# **NRC Staff Evaluation of the Next Generation Attenuation for Central and Eastern North America Project (NGA-EAST) Ground Motion Model Characterization**

Date Published: September 2020

This research information letter (RIL) is in response to the New Reactor Office, Division of Licensing, Siting and Environmental Analysis' (DLSE)<sup>1</sup> request to the Office of Research (RES), Division of Engineering (DE) for technical assistance in the review of the Next Generation Attenuation for Central and Eastern North America Project (NGA-East) Ground Motion Characterization Model (GMC) (ML19037A460). This RIL documents the review of the NGA-East GMC model by RES staff to ensure that the model is suitable for siting evaluations of nuclear power plants in the central and eastern United States (CEUS). This report summarizes the recently published NGA-East GMC model and describes details of the sensitivity analyses performed by RES staff in order to support the licensing office's decision to endorse and justify the adequacy and technical accuracy of the new GMC model.

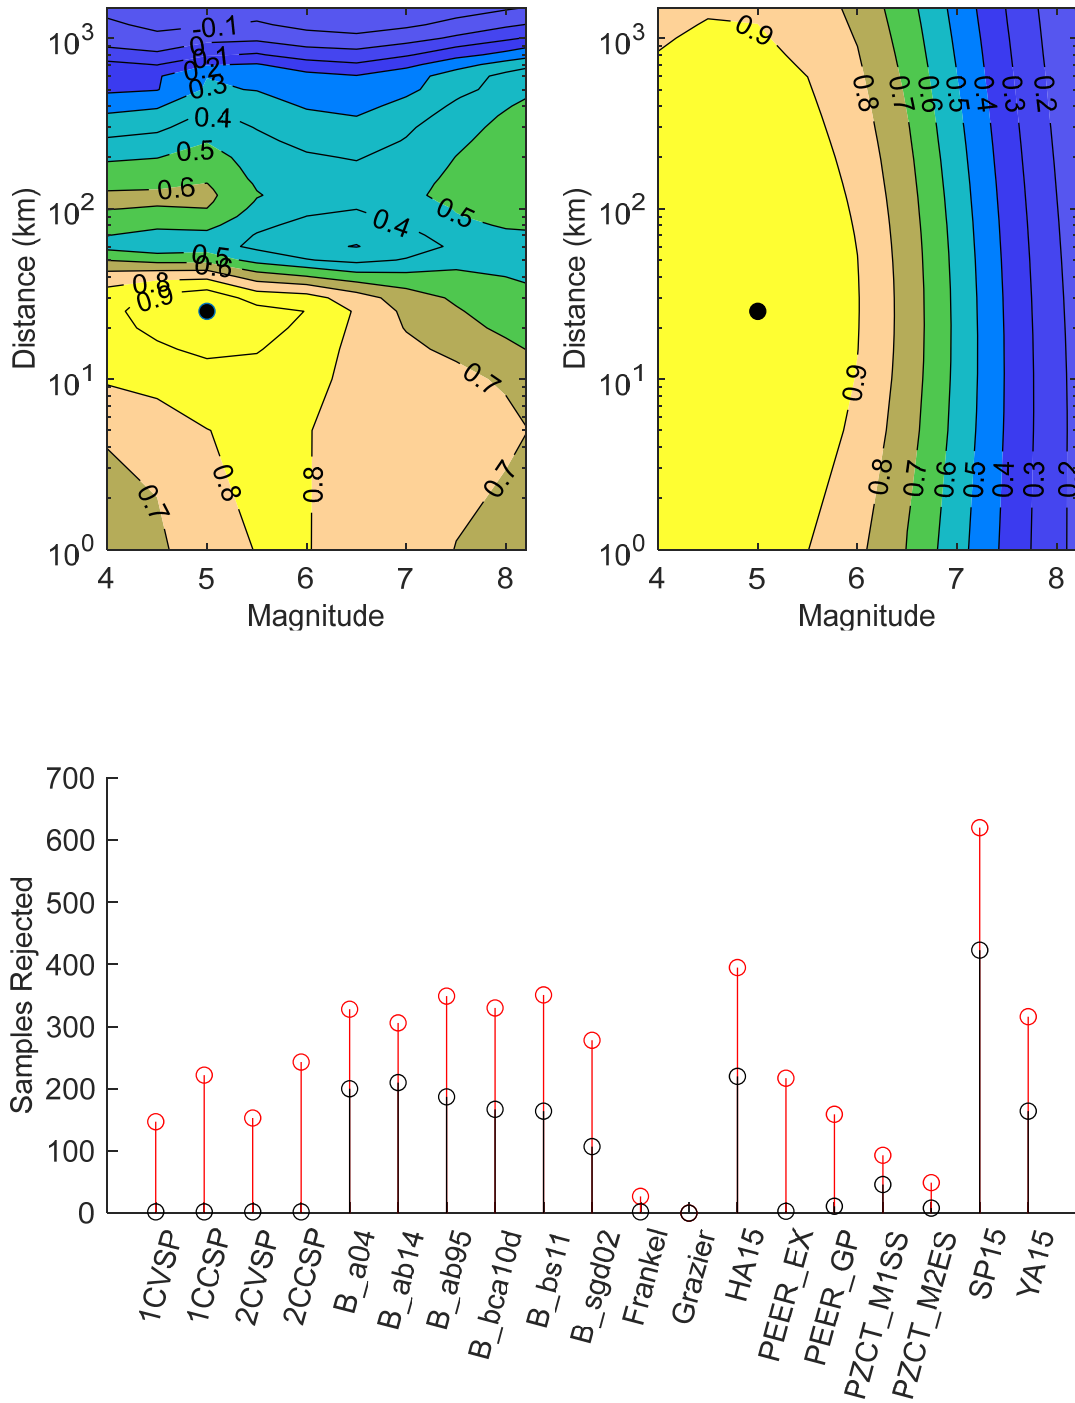
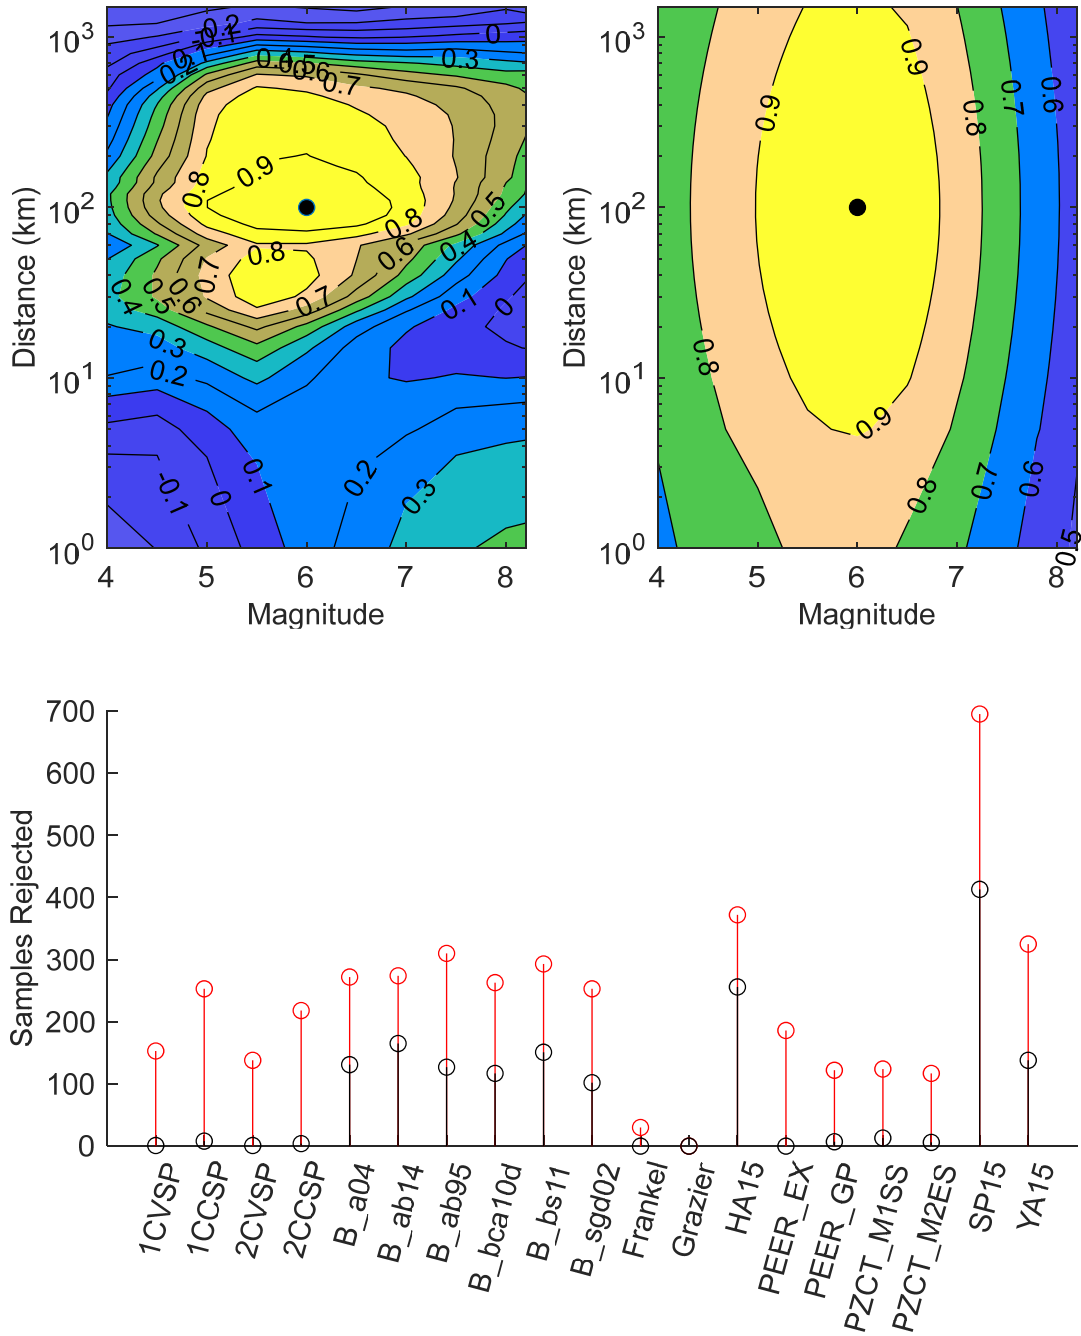
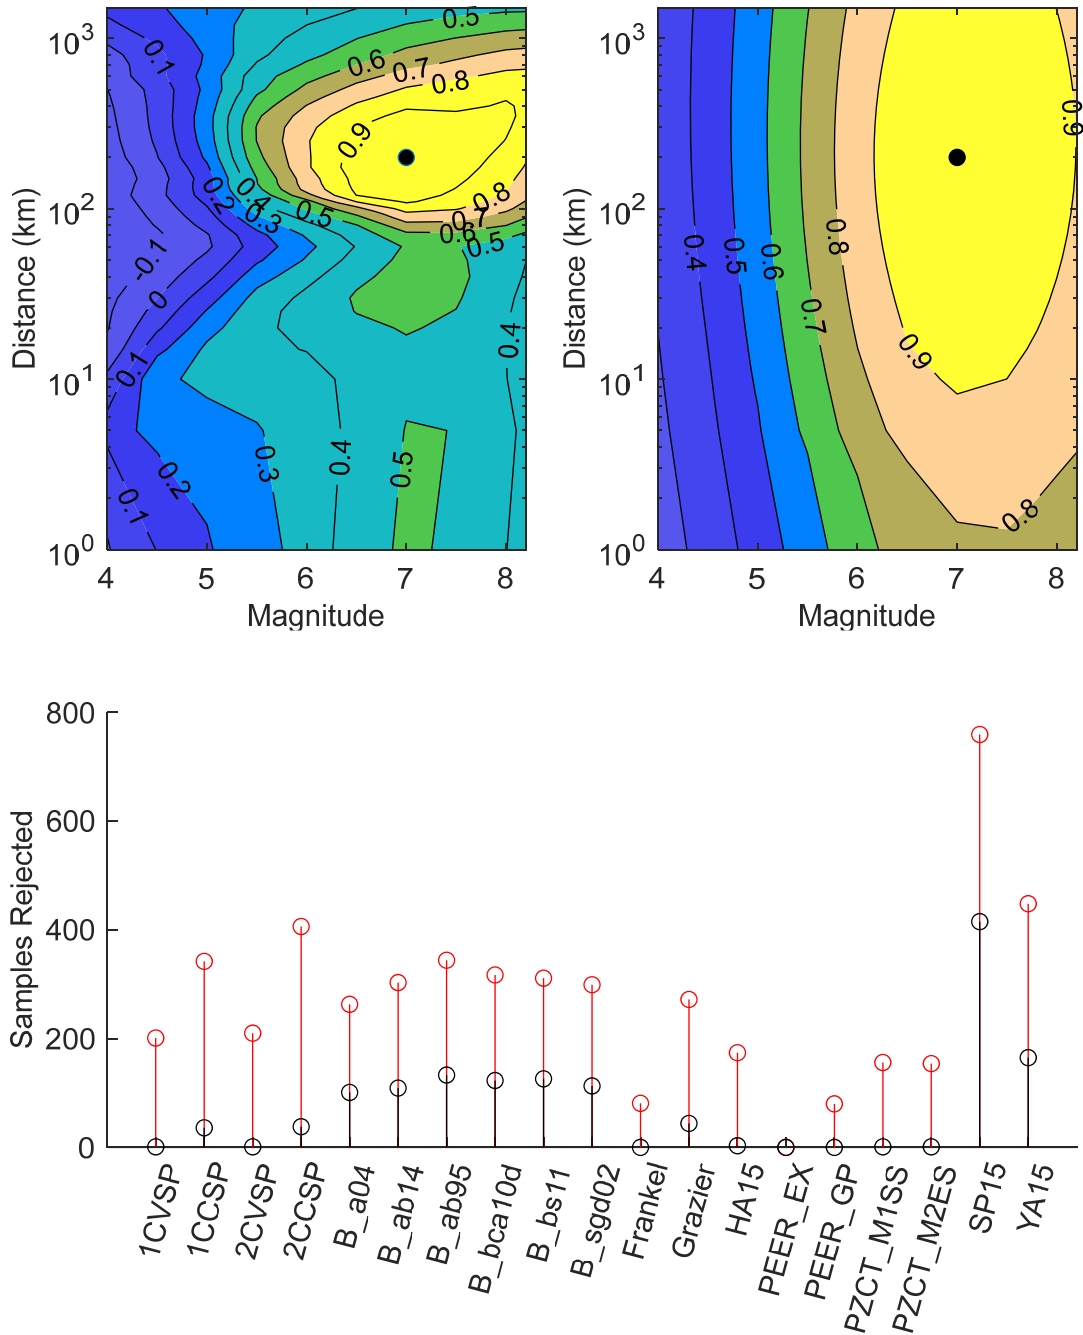
1. A significantly larger number of generated models are rejected due to not meeting the physicality constraints established by the TI team and described in Section 8.3.2 of NGA-East. Figure 5.1-Figure 5.3 (bottom) show how implementing a Gaussian process regression to the correlation model can greatly reduce the number of models being rejected.
2. A narrowing of the ground motion distribution can occur due to lack of physically realistic models being sampled from the tails of distribution.

What was not clear to RES staff, is whether implementing GP regression on the seed GMM correlation results in a distribution of ground motions consistent with the seed models. Therefore, sensitivity analyses were performed by the RES staff to determine the appropriateness of the GP regression correlation model by comparing the resulting ground motion distributions of the seed GMM correlation model and the GP regressed correlation model. The resulting ground motion distributions using the models in Figure 5.1 - Figure 5.3 are shown in Figure 5.4 - Figure 5.6. No significant change in the mean of the distributions occurs between correlation models; however, there is a slight increase in the variance using the GP regressed correlation model. The increase in variance can be explained by the fact that the GP regressed model is smoother with changes in magnitude and distance. Thus, models generated from samples drawn near the tails of the distribution are more likely to produce physically reliable models. Similar results were found for all magnitude and distance scenarios across all seismic hazard frequencies. As a result, the staff concludes that the TI team's use of Gaussian process regression not only produces ground motion distributions consistent with the seed models but also allows for a broader range of the epistemic uncertainty in ground motion estimates to be captured.

RES Staff expressed concern with the Gaussian Process regression used to smooth the ground motion correlation that informs the selection of the median models. Sensitivity analyses were performed by RES Staff to compare the resulting ground motion distributions from both the seed and GP regressed correlation models. The results show that the GP regression approach used by the TI Team is an effective approach for sampling the ground motion space while preserving the ground motion distribution associated with the seed GMMs (Section 4.1 ).

Figure 5.7. Peak ground motion distributions for  $M=5$  and  $R_{RUP}=25$  km sampled from multivariate distribution informed by  $R_{RUP}$  vector with maximum values of 1500 km (red) and 800 km (black dashed) respectively.

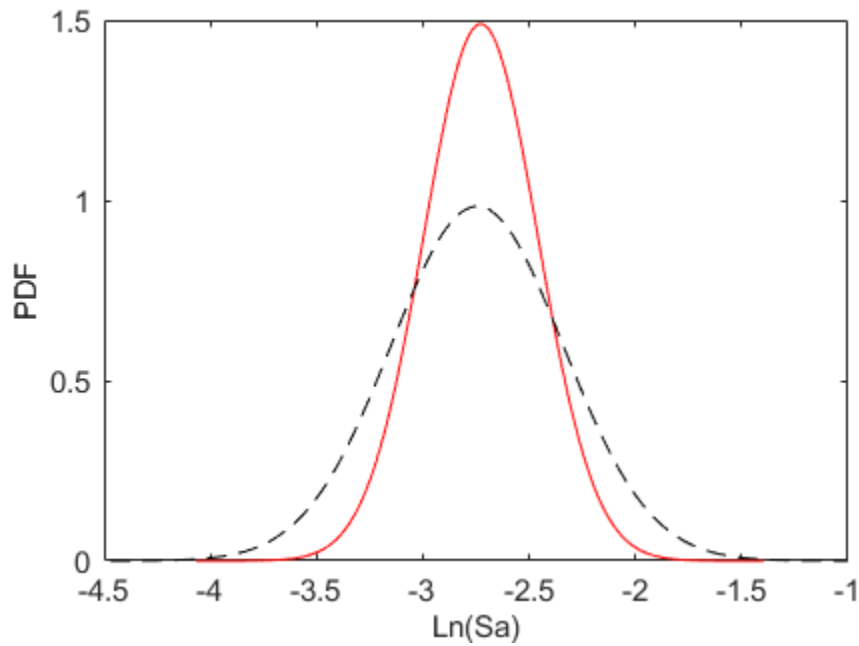
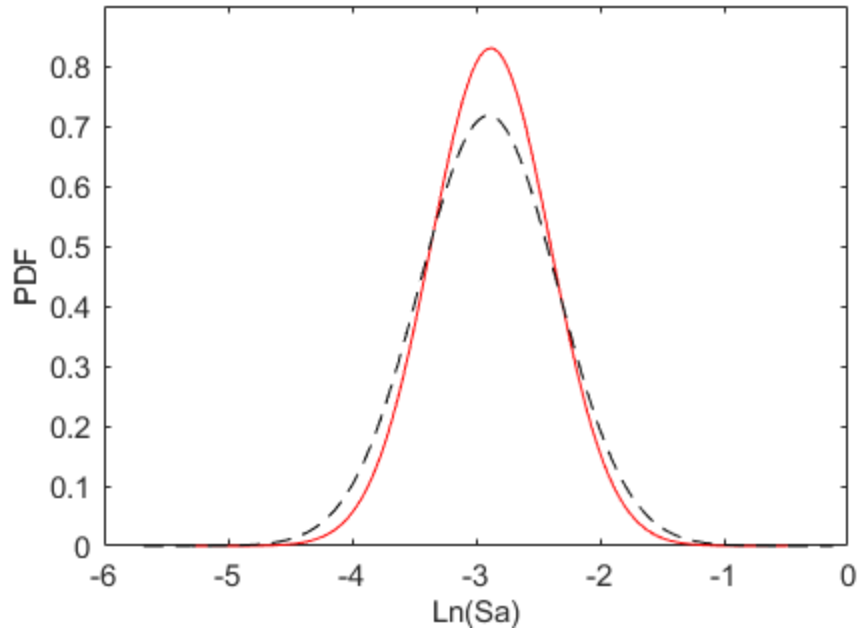
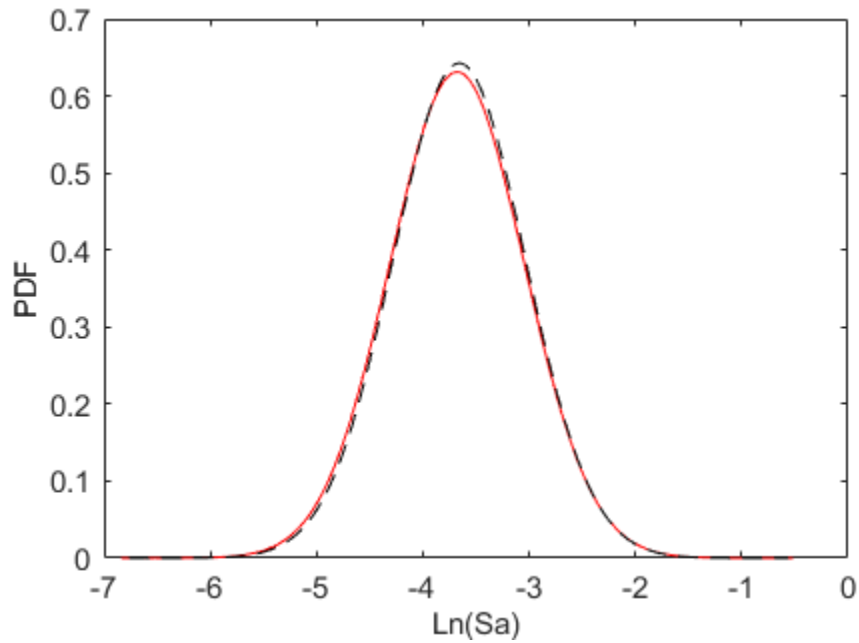
Section 8.4 of NGA-East describes the selection of the  $M$  and  $R_{RUP}$  scenarios (listed above in Section 3.1 ) used to capture the epistemic uncertainty in median ground motions. The TI team decided that distances out to 1500 km were required for sites in regions of low seismicity where ground motions from large-distant earthquakes contribute significantly to site hazard. What was not clear to RES staff was if truncating the maximum  $R_{RUP}$  distance of 1500 km to a shorter distance typically used in probabilistic seismic hazard analyses (PSHA) for high seismicity zones would affect the resulting ground motion distributions. In other words, was the TI teams decision to use distances out to 1500 km where most GMMs are not necessarily reliable have an adverse effect on the resulting ground motion distributions.

Therefore, RES staff performed sensitivity analyses by truncating the maximum  $R_{RUP}$  distance to 800 km and comparing the resulting ground motion distributions to those of the NGA-East maximum  $R_{RUP}$  distance of 1500 km. The results show an increase in the variability for the  $M$  5,  $R_{RUP}$  25 km scenario with the increased variability diminishing with larger  $R_{RUP}$  as shown in Figure 5.7-Figure 5.9. The increase in variability with a decrease in  $R_{RUP}$  is consistent across all  $M$  and most pronounce for small magnitudes  $\leq 5$ . This effect can be explained by the combination of a reduction in the number of dimensions sampled and the sparseness of ground motions for larger  $R_{RUP}$ . The truncation of  $R_{RUP}$  results in a multivariate distribution of ground motion with 33 less dimensions to be sampled. This reduction allows for a more refined sampling of the ground motion space that is coupled by higher resolution of ground motions at shorter  $R_{RUP}$ . RES staff considered the above results and concluded that there would be essentially no impact on the final mean hazard from decreasing the maximum  $R_{RUP}$  distance to 800 km. In addition, because only a limited number of the total  $M$  and  $R_{RUP}$  scenarios are affected, there will be no significant effects on the resulting epistemic uncertainty in the median ground motions.

RES Staff also expressed concern with the maximum  $R_{RUP}$  distance of 1500 km used in the NGA-East GMC compared to shorter distances typically used in PSHAs. The TI team selected the larger distance to account for regions of low seismicity where larger-distant events control hazard. Sensitivity analyses performed by RES Staff compared the ground motion distributions from both the NGA-East GMC model, which uses a maximum  $R_{RUP}$  distance of 1500 km, and an alternative GMC model with a maximum  $R_{RUP}$  distance of 800 km. The results show that the reduction in the maximum  $R_{RUP}$  produces a small increase in ground motion variability for small magnitudes at short distances; however, RES Staff concludes that there would be essentially no impact on the mean hazard since only a limited number of the total  $M$  and  $R_{RUP}$  scenarios are effected (Section 4.2 ). Therefore, RES Staff concludes that the NGA-East GMC model is appropriate for regions of both high and low seismicity and that the maximum  $R_{RUP}$  distance of 1500 km is not an issue.

Figure 5.10. Peak ground motion distributions for  $M = 5$  and  $RRUP = 25$  km sampled from multivariate distribution informed by NGA-East seed models (red) and updated/removed models (black dashed) respectively.

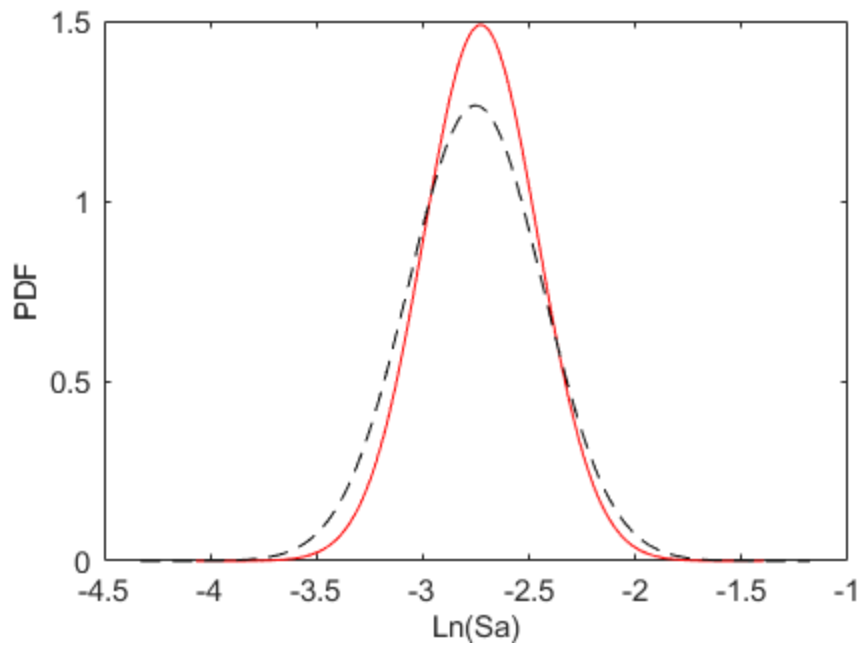
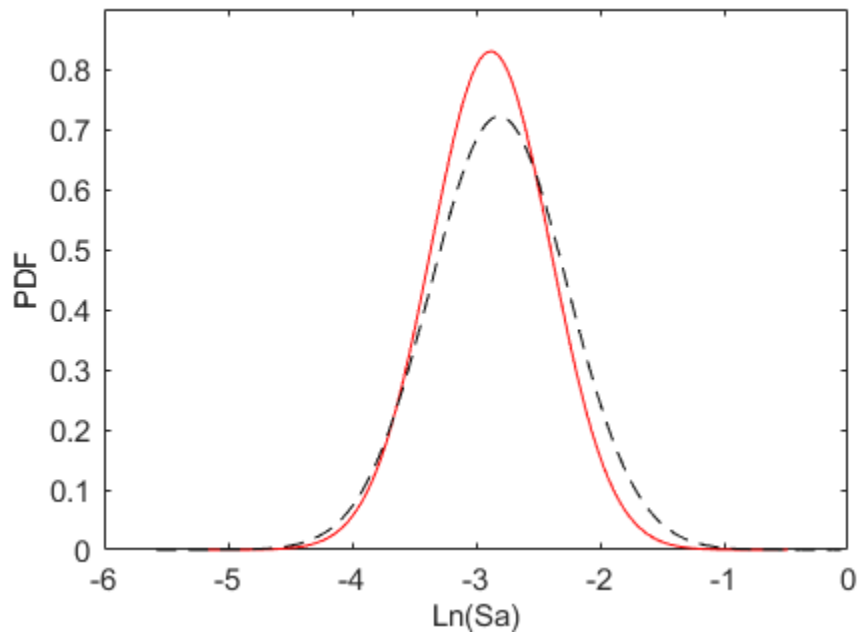
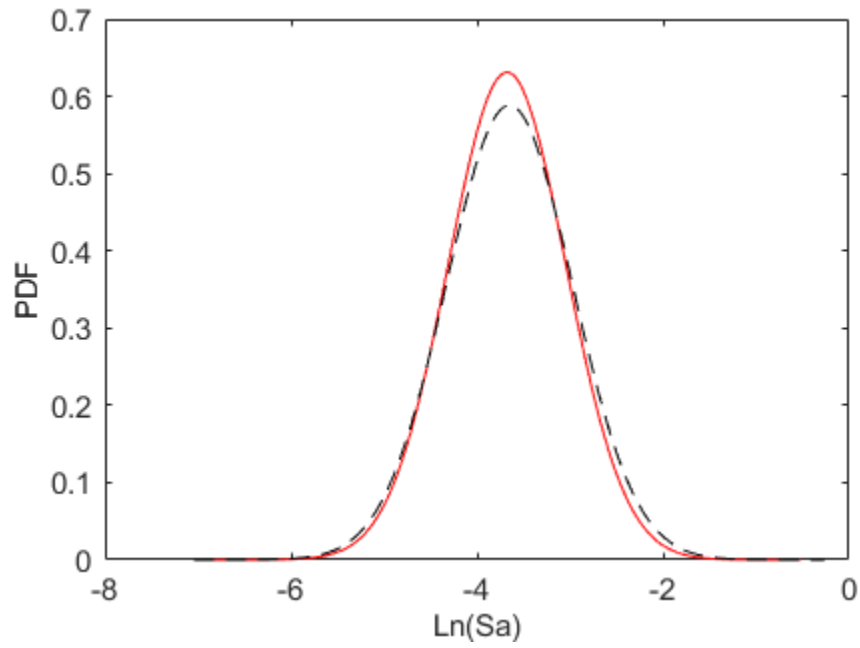
Due to the prolonged effort of the NGA-East project, RES staff was unsure if updating the seed GMMs would significantly change the final 17 median NGA-East GMMs developed by the TI

Figure 5.10 - Figure 5.12 compare the resulting ground motion distributions from both the NGA-East model and the alternative GMC model described above. The results show the distribution of ground motion resulting from the alternative GMC model to be only slightly different from that of the NGA-East model with no significant change in the mean or standard deviation. Similar results were found for all magnitude and distance scenarios across all hazard significant frequencies. As a result, RES Staff is confident in the regulatory stability of the NGA-East GMC for use in future PSHAs for nuclear power plants.

Lastly, due to the prolonged effort of the NGA-East project, RES Staff examined the stability of the final NGA-East GMC model by updating the set of seed GMMs to determine the impact on the final median models. Sensitivity analyses performed by RES Staff compared the resulting ground motion distributions using both the NGA-East set of seed models and a set of alternative set of updated seed models. The results show no significant change in the ground motion distributions from the alternative sets of seed GMMs. This result leads RES Staff to conclude that the NGA-East GMC model provides a stable and robust estimate of median ground motions for use in PSHAs for CENA sites.
